CNL-19-038

June 7, 2019

Watts Bar Nuclear Plant, Units 1 and 2
Facility Operating License Nos. NPF-90 and NPF-96
NRC Docket Nos. 50-390 and 50-391

Subject: **License Amendment Request to Make Miscellaneous Administrative Changes (WBN-TS-19-02)**

Figure 4.1-1 (page 1 of 1)
Site and Exclusion Area Boundaries

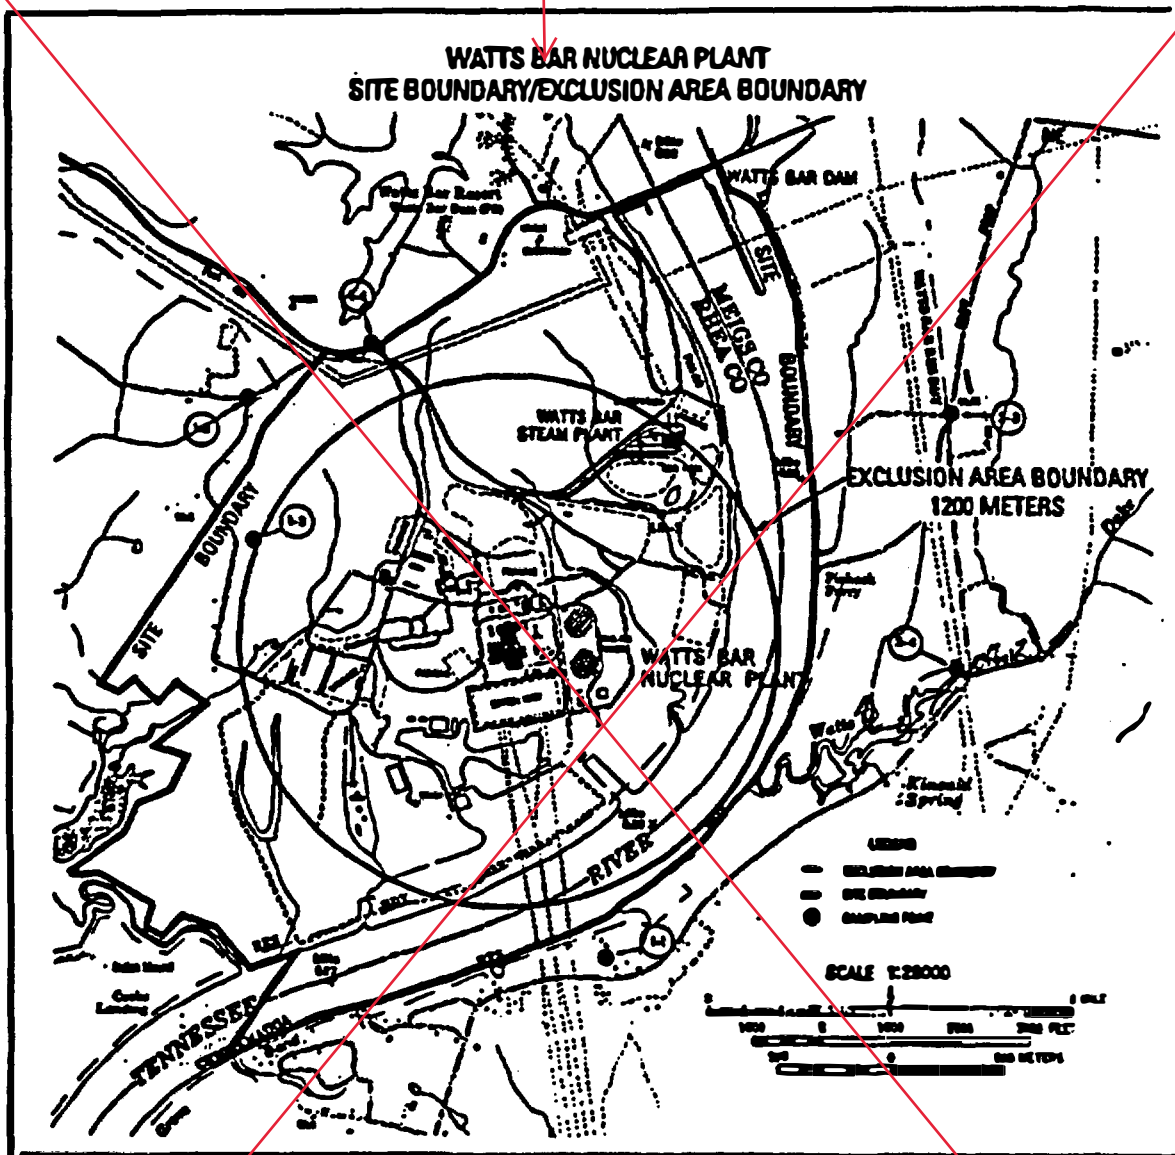
This license amendment request proposes to revise TS Section 4.0, Design Features, Page 4.0-1, by deleting the text in TS 4.1.1 and 4.1.2 (that refers to Figures 4.1-1 and 4.1-2), and adding a description of the site location in Section 4.1, "Site." Figures 4.1-1 and 4.1-2 are removed from Pages 4.0-5 and 4.0-6, and "Page Intentionally Left Blank" text is inserted. This also results in a revision to the List of Figures in the TOC.

The removal of the figures and adding a text description of the site location are administrative changes. The text is derived from Chapter 2 of the dual-unit WBN Updated Final Safety Analysis Report (UFSAR). Additionally, the information on these figures is depicted in UFSAR Figures 2.1-4B and 2.1-3. This change is made to promote consistency with the STS, and the TS of other TVA nuclear sites, which do not include these figures.

~~The site and exclusion area boundaries shall be as shown in Figure 4.1-1.~~

The Watts Bar Nuclear Plant is located on a tract of approximately 1770 acres in Rhea County on the west bank of the Tennessee River at river mile 528. The site is approximately 1-1/4 miles south of the Watts Bar Dam. The 1770 acre reservation is owned by the United States and is in the custody of TVA. The exclusion area is determined by a circle of radius 1200 meters centered on a point 20 feet from the north wall of the turbine building along the building centerline. The distance to the low population zone is a radius of 3 miles.

Figure 4.1-2 (page 1 of 1)
Low Population Zone

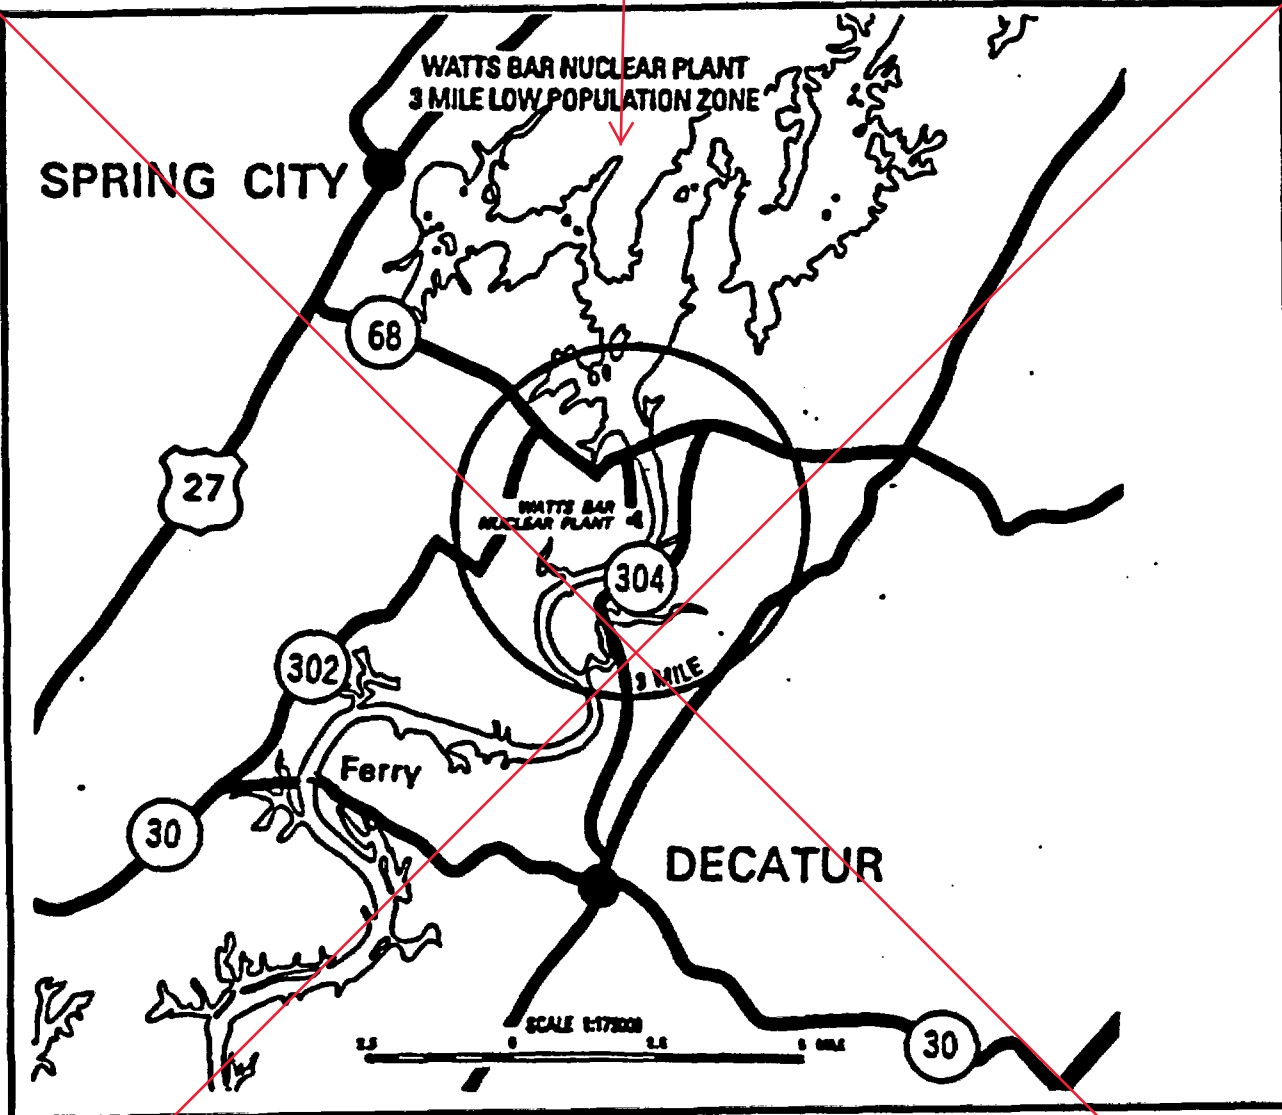
~~The LPZ shall be as shown in Figure 4.1-2 (within the 3-mile circle).~~

FIGURE 4.1-1 (PAGE 1 OF 1)
SITE AND EXCLUSION AREA BOUNDARIES

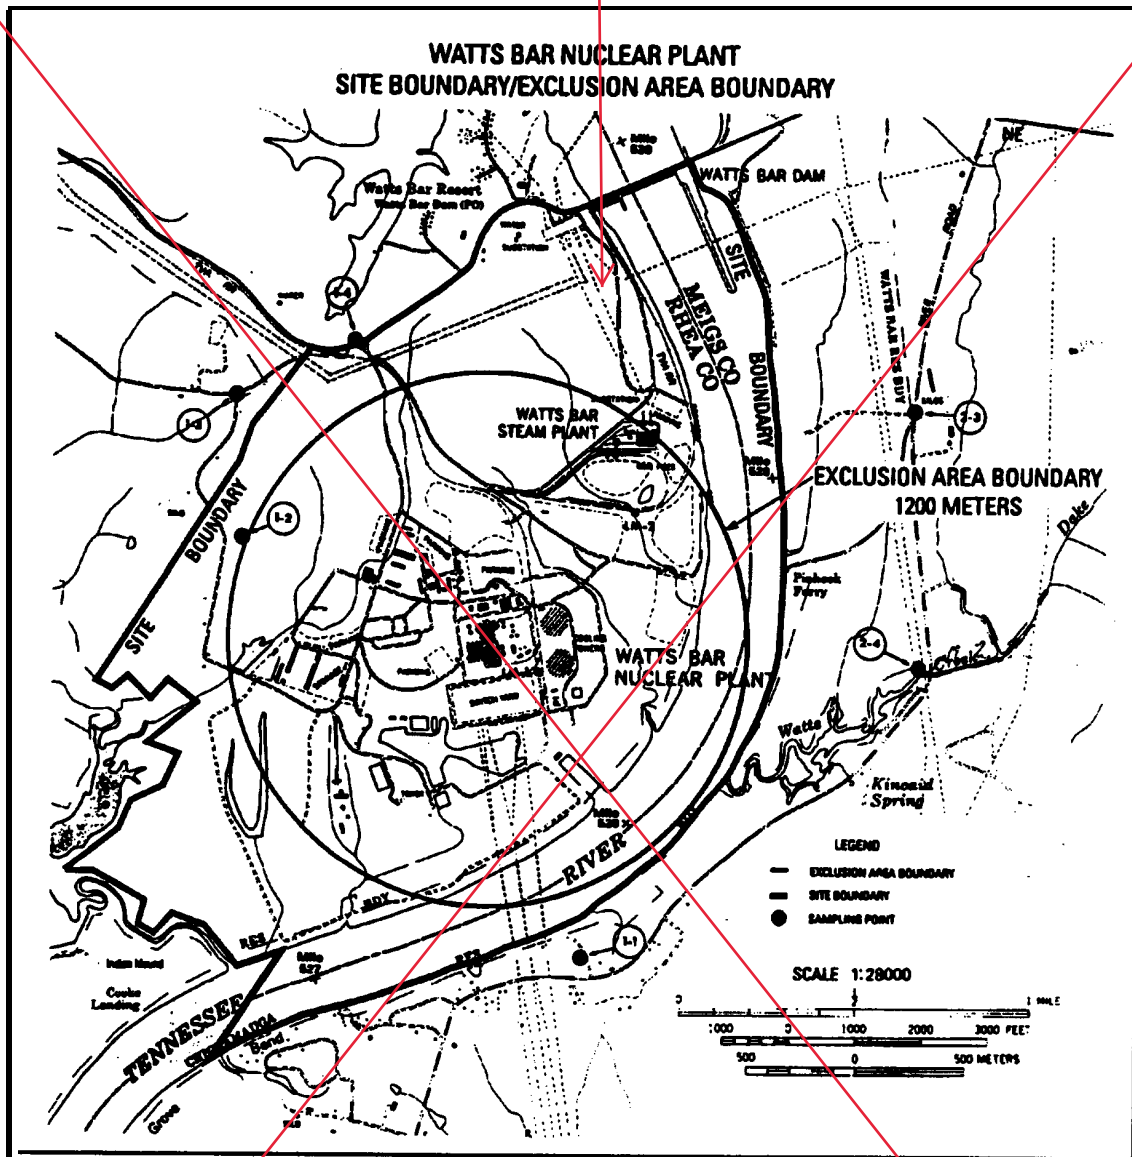
~~The site and exclusion area boundaries shall be as shown in Figure 4.1-1.~~

The Watts Bar Nuclear Plant is located on a tract of approximately 1770 acres in Rhea County on the west bank of the Tennessee River at river mile 528. The site is approximately 1-1/4 miles south of the Watts Bar Dam. The 1770 acre reservation is owned by the United States and is in the custody of TVA. The exclusion area is determined by a circle of radius 1200 meters centered on a point 20 feet from the north wall of the turbine building along the building centerline. The distance to the low population zone is a radius of 3 miles.

FIGURE 4.1-2 (PAGE 1 OF 1)
LOW POPULATION ZONE

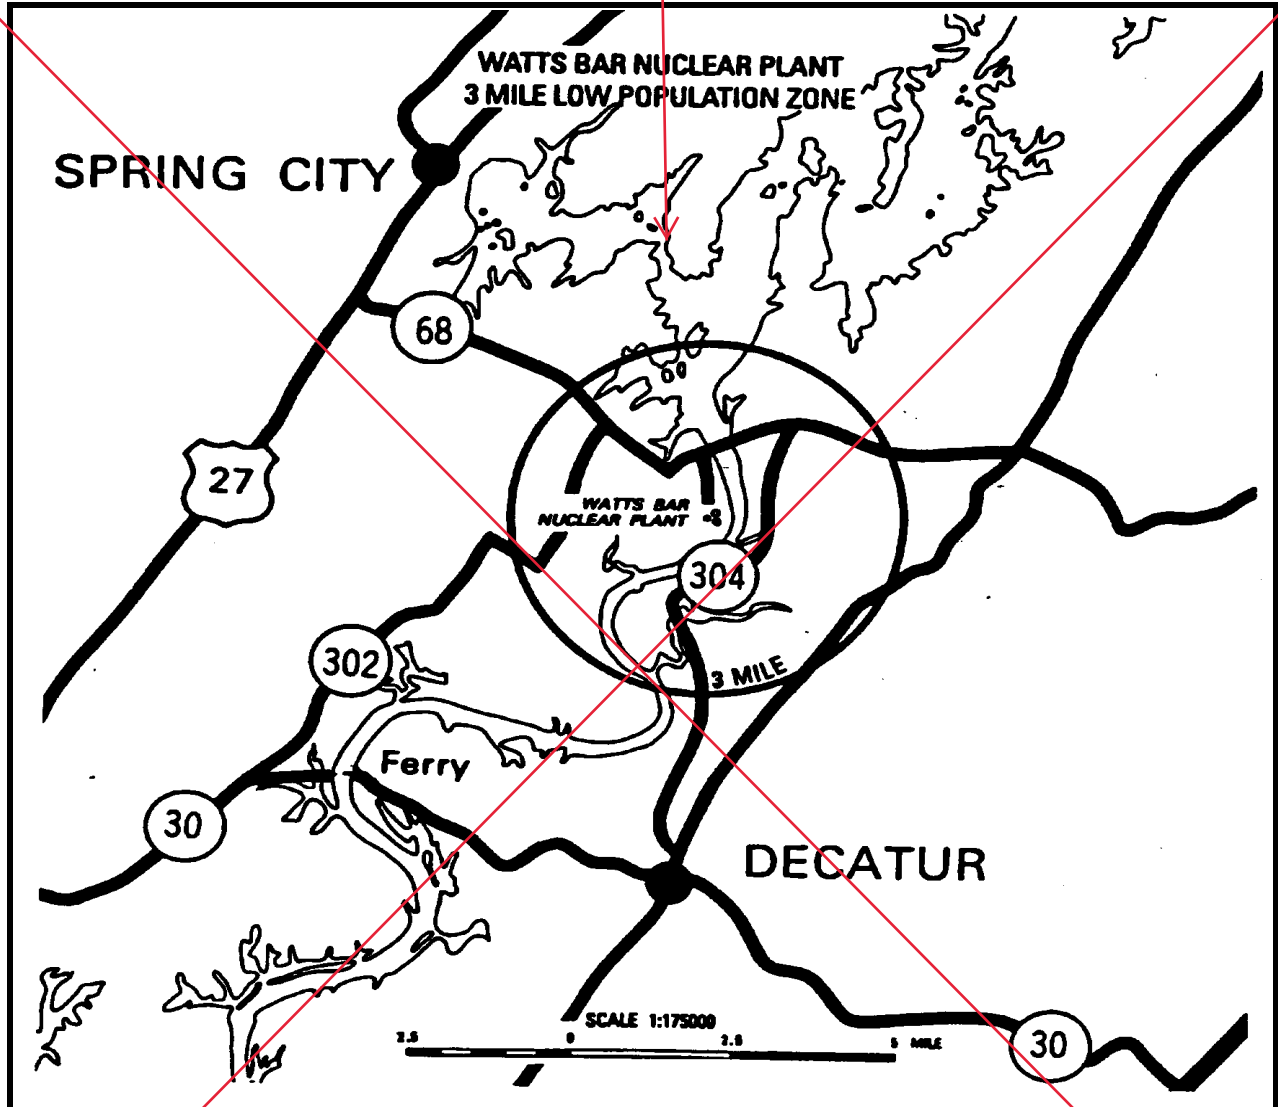
~~The LPZ shall be as shown in Figure 4.1-2 (within the 3-mile circle).~~
